From: Jonathon Weston <[REDACTED]@ballymoregroup.com>
Sent: 01 April 2016 14:04
To: Matt Christie
Cc: COUGHLAN, Tony; Julian Shirley ([REDACTED]@dp9.co.uk)
Subject: RE: The Goodsyard
Attachments: The Goodsyard - Daylight Report

This document is supplementary to the EIA Chapter on daylight, sunlight and overshadowing dated June 2015 as submitted with planning application PA/15/02011 and 2014/2425 for the Bishopsgate Goodsyard site. It does not provide any new information but rather represents the numerical results and observations in the original document in a different format and structure. The intention

GIA have been instructed to review the report dated 14 March 2016 by GVA on the daylight and sunlight to the key properties, and to provide further clarification on the numerical discrepancies. This letter therefore seeks to provide further clarification as to the differences in the number of windows assessed as meeting the BRE VSC criteria (first test set by GVA) and of the remaining those which have a VSC greater than 15%.

154 Commercial Street VSC Compliant (27% VSC or 20% loss)

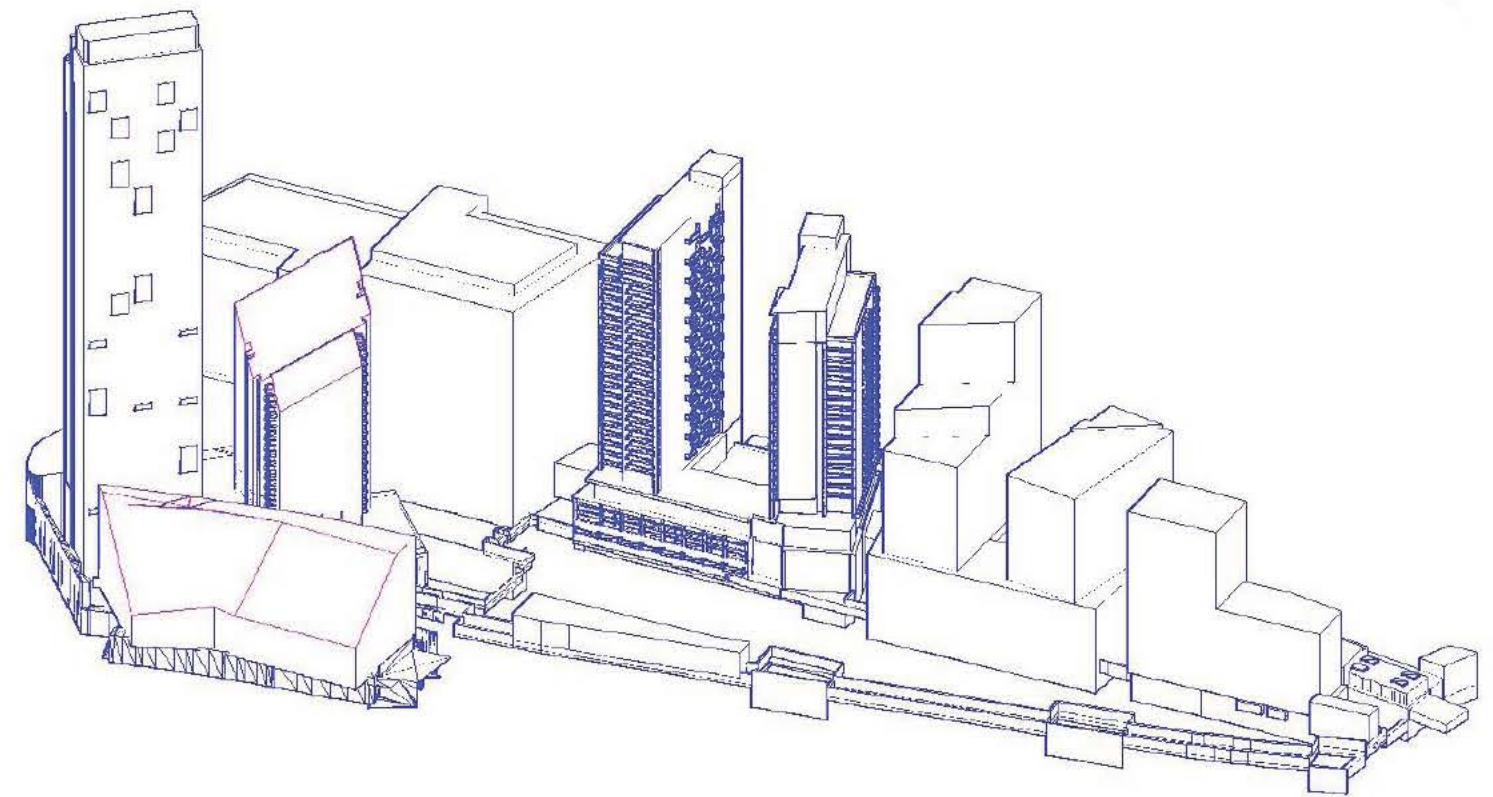
Halfway position for 154 Commercial Street (approximately 15 % retained VSC or 3% absolute loss)

Comparison exercise to understand impacts of maximum and minimum parameters as well as adjustment to Block D on Telford Homes.

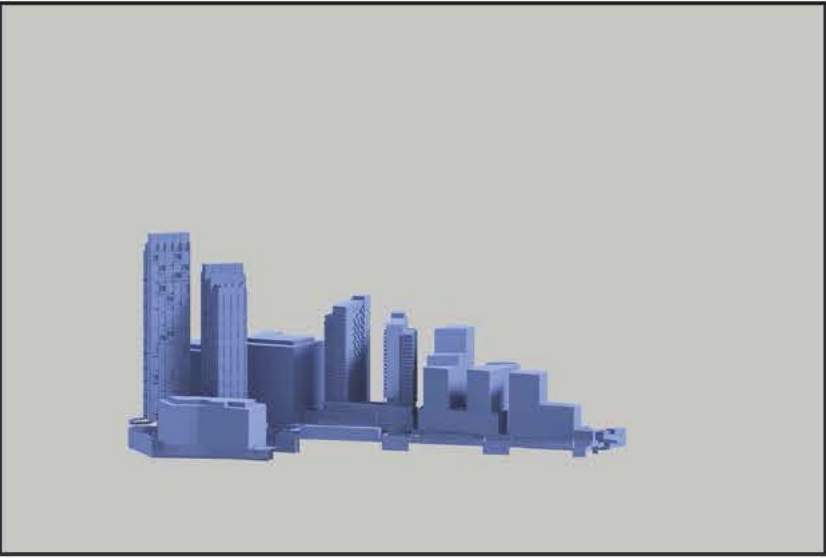
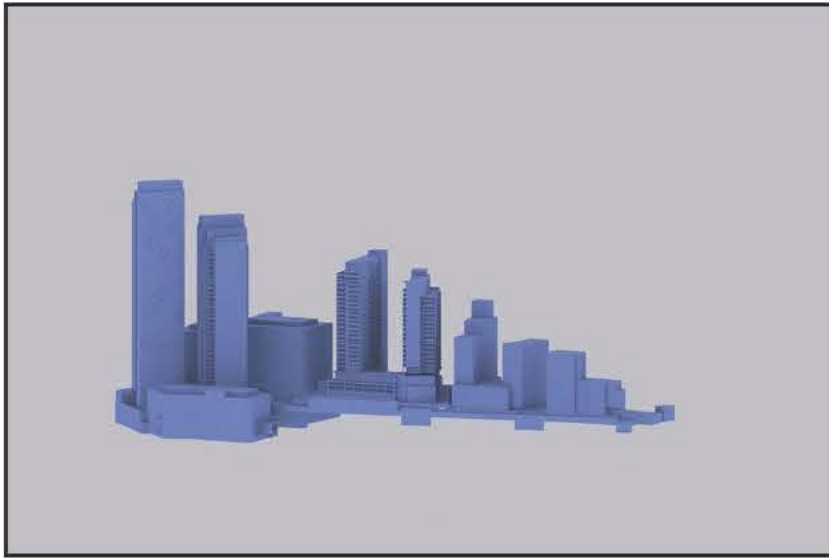
As shown below, whilst removing the tall tower of Block D would reduce the impacts to Telford Homes, the minimum parameter would improve the levels of daylight further.

Cutback to BGY scheme (retained 15% VSC or <3% absolute change in Telford Homes Block A and Hollywood Lofts)

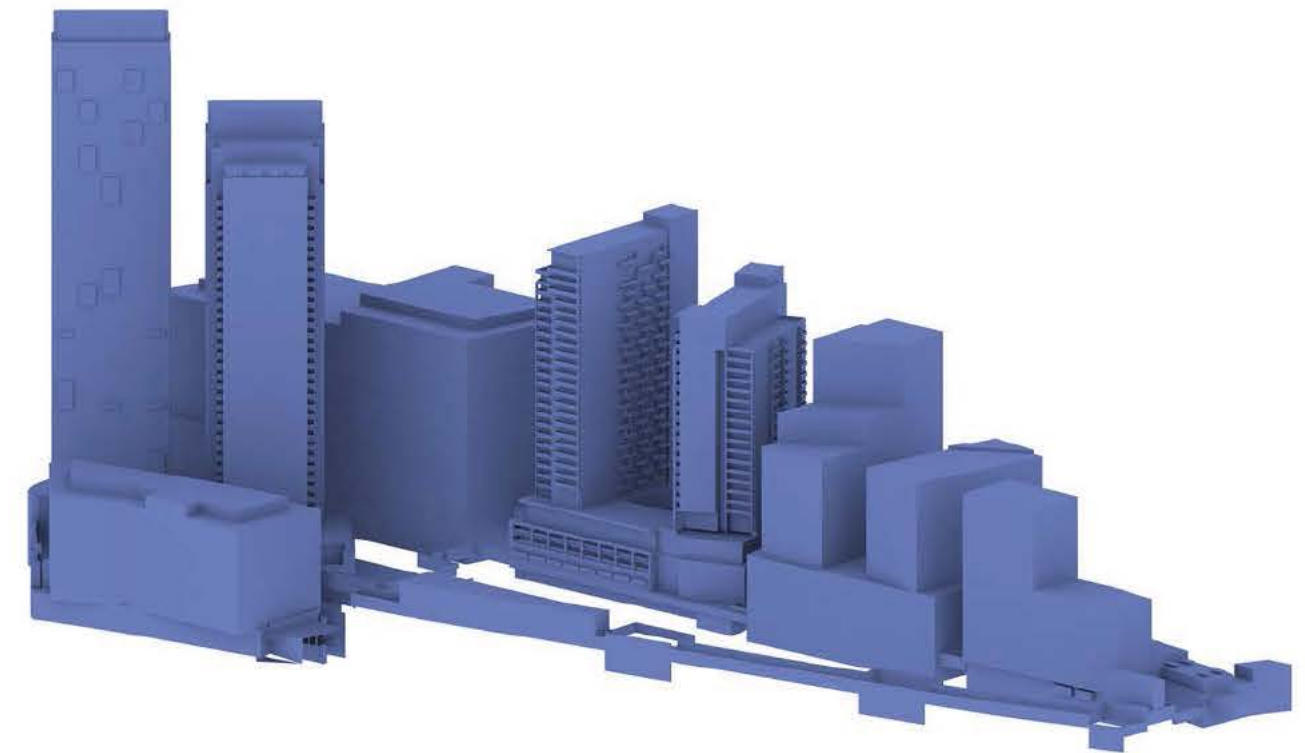
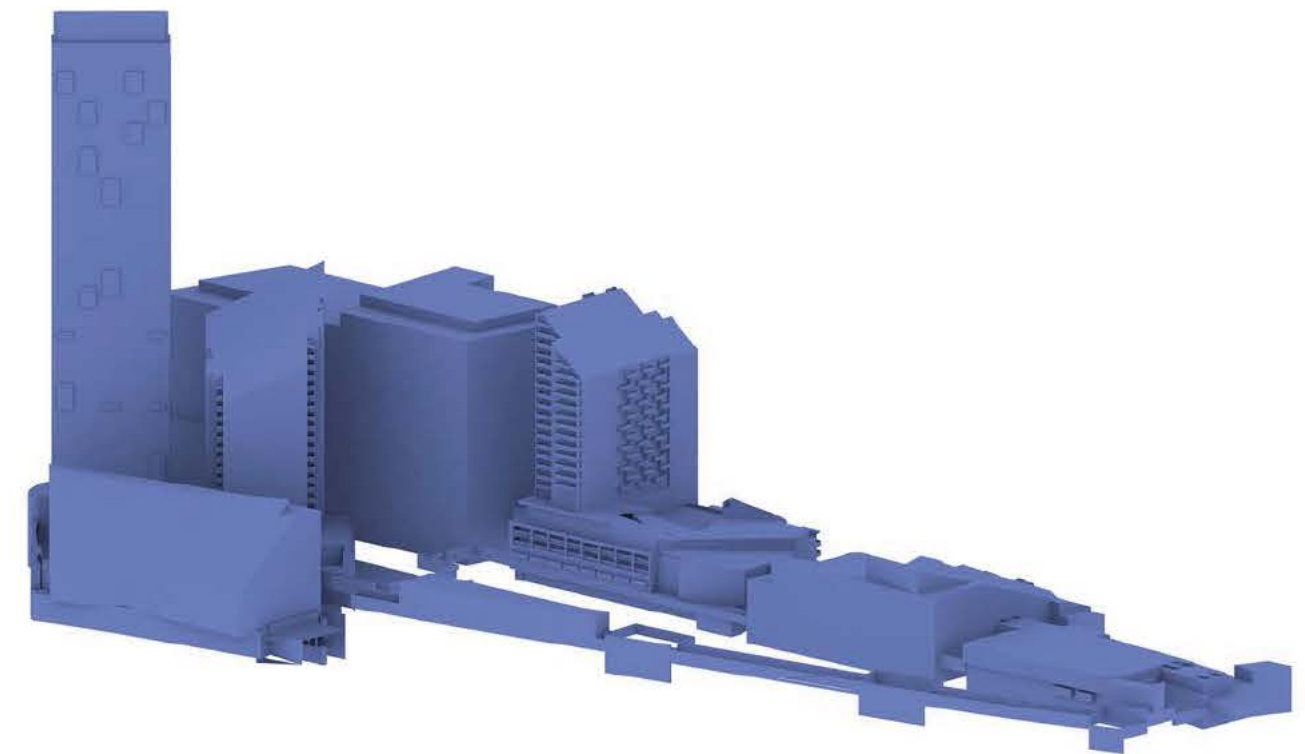
- The mitigating points include the fact that other adjacent consents have permitted similar levels of impacts and retained light. In fact, with Telford Homes there are actually existing values of light which are similar. In addition, there are no small modifications to the scheme which can easily address the position with these two properties.
